THE MANITOBA WATER SERVICES BOARD

CONTRACT NO. M.W.S.B. 1393

**MUNICIPALITY OF GLENELLA-LANSDOWNE
WATER TREATMENT PLANT UPGRADES**

ADDENDUM NO. 1

MUNICIPALITY OF GLENELLA-LANSDOWNE WTP UPGRADES			
DISCHARGE PIPE PROFILE & DETAILS			
SCALE	DATE	PROJECT NUMBER	REVISION
NTS	17-07-25	1393	2 of 4

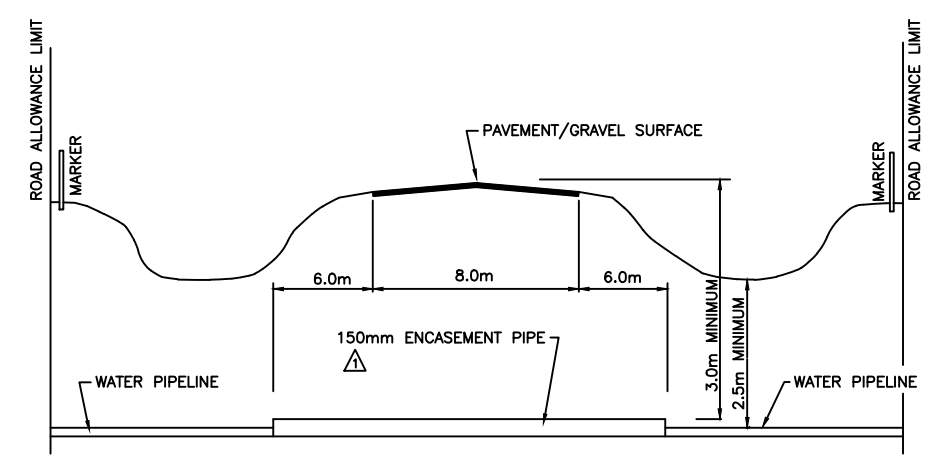
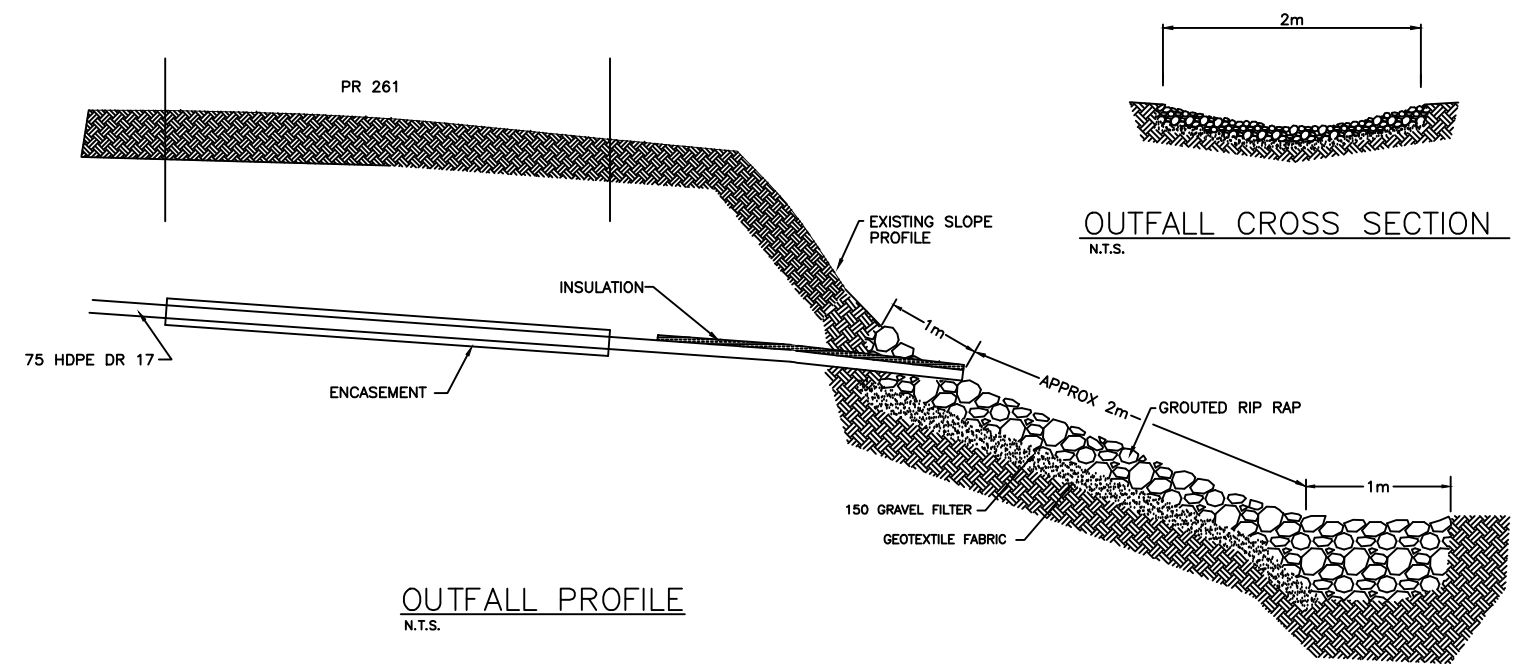
Page 2 of 4 – change in diameter of encasement pipe and removal of cross section detail

NO.	DESCRIPTION	BY	DATE
1	CHANGE OF DIMENSION & REMOVAL OF CROSS SECTION	NLL	17-09-12

MUNICIPALITY OF GLENELLA-LANSDOWNE WTP UPGRADES				
DETAILS				
SCALE	DATE	PROJECT NUMBER	REVISION	SHEET
N.T.S.	17-07-24	1393	4	4

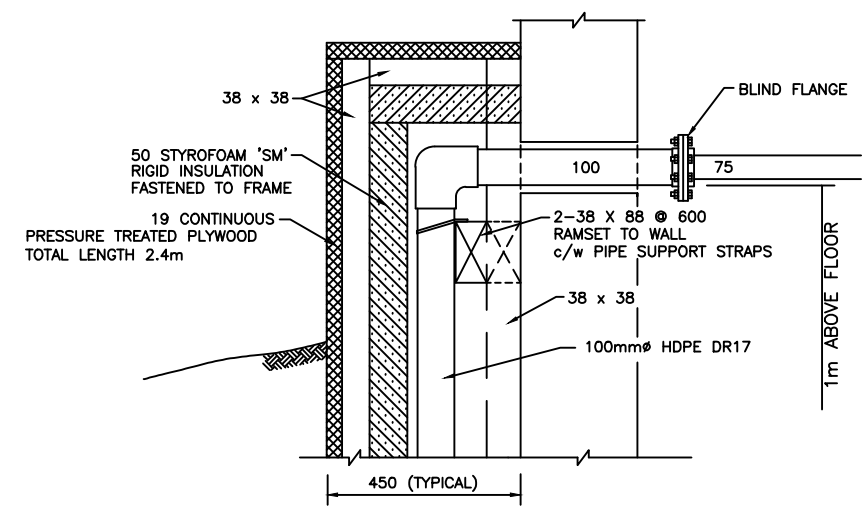
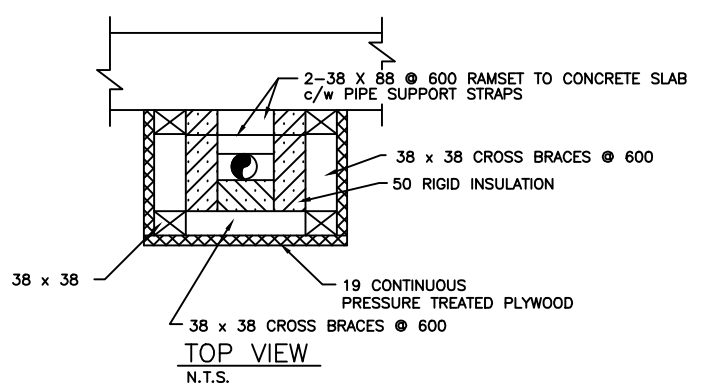
Page 4 of 4 – clarification on curb stop for air release valve

NO.	DESCRIPTION	BY	DATE
1	CLARIFICATION	NLL	17-09-12
